title  
**Western Precinct Plans**  
**Western Precinct Learning Hub - Lower**  
**Ground 4 Plan**

## PROPOSED MODIFICATIONS

project  
**Loreto Kirribilli Innovation Centre**  
85 Carabella St  
Kirribilli NSW 2061

title  
**Elevations  
Elevations 2- Western Precinct Learning  
Hub**

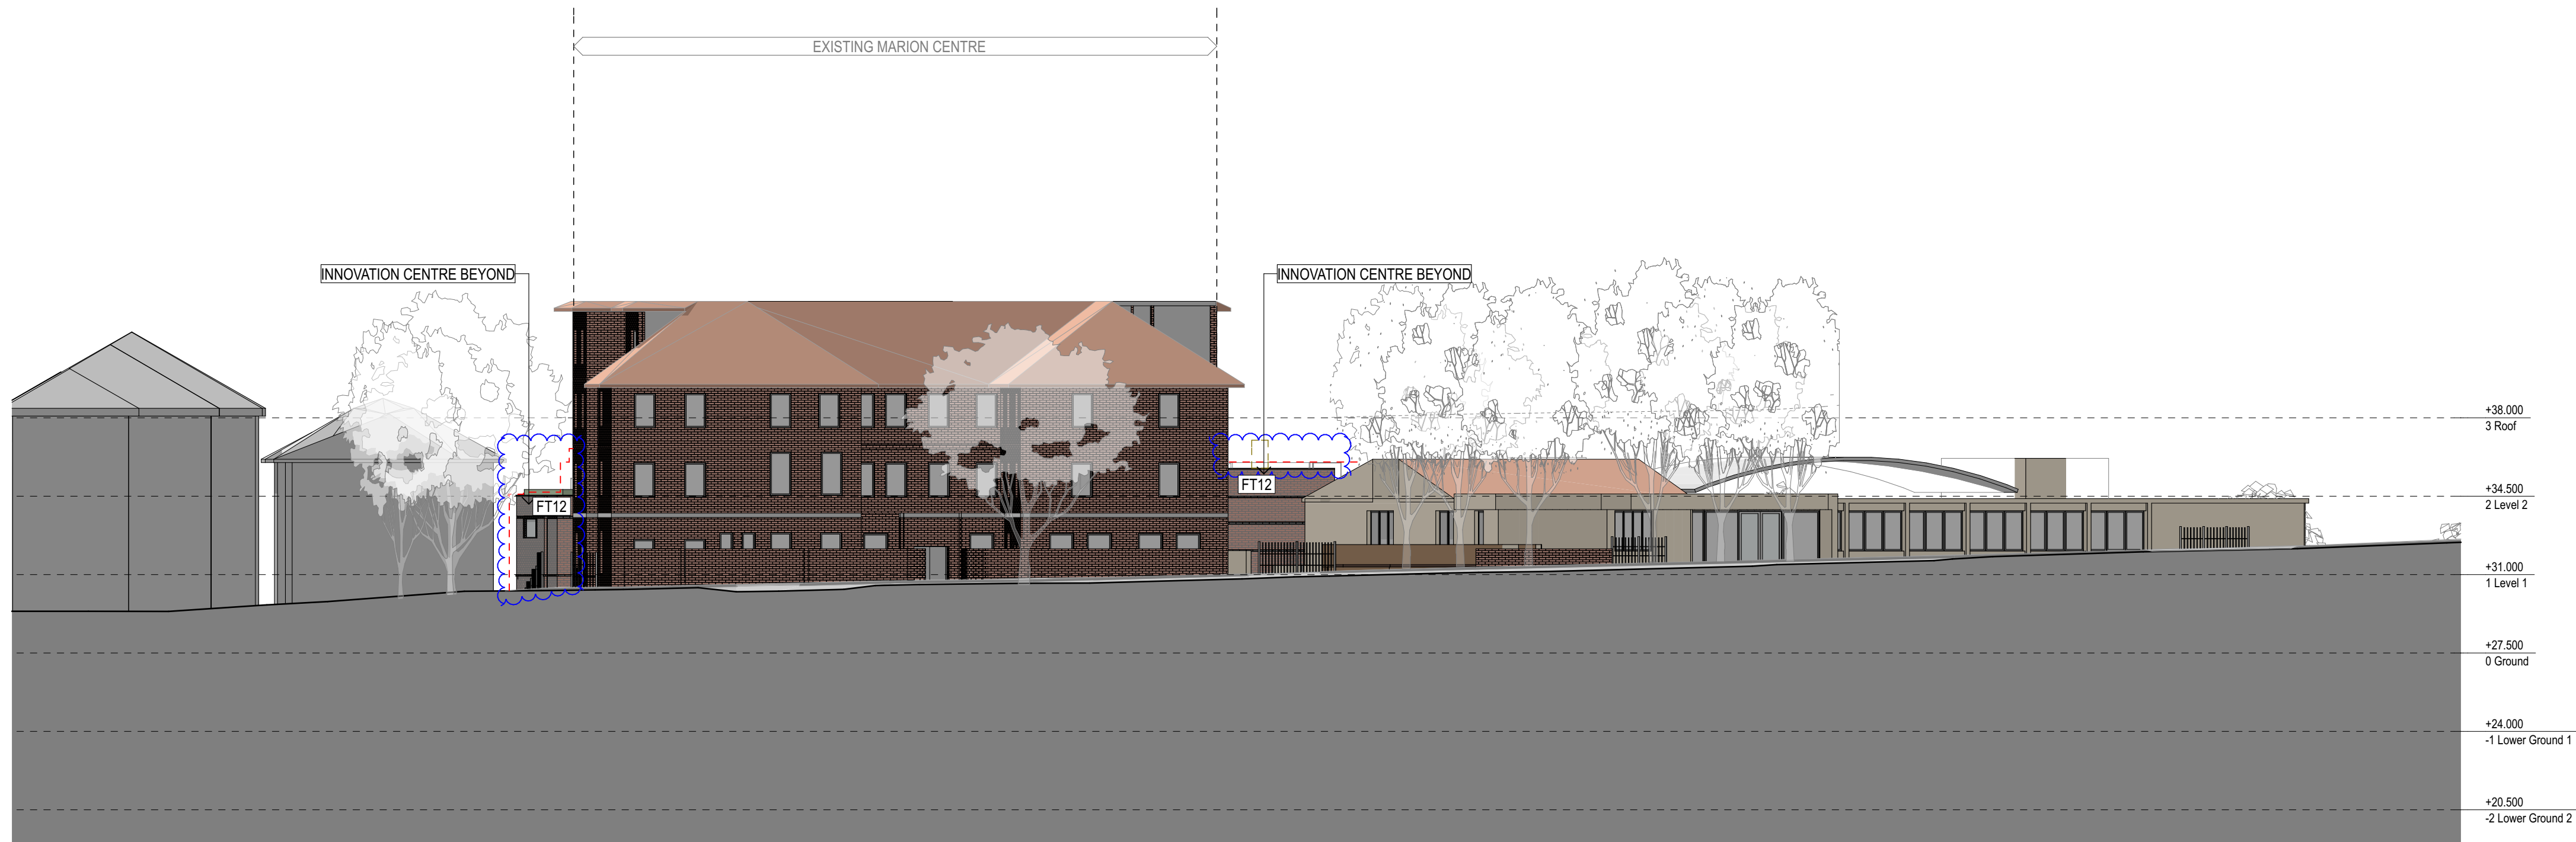
PROPOSED MODIFICATIONS

PROPOSED MODIFICATIONS
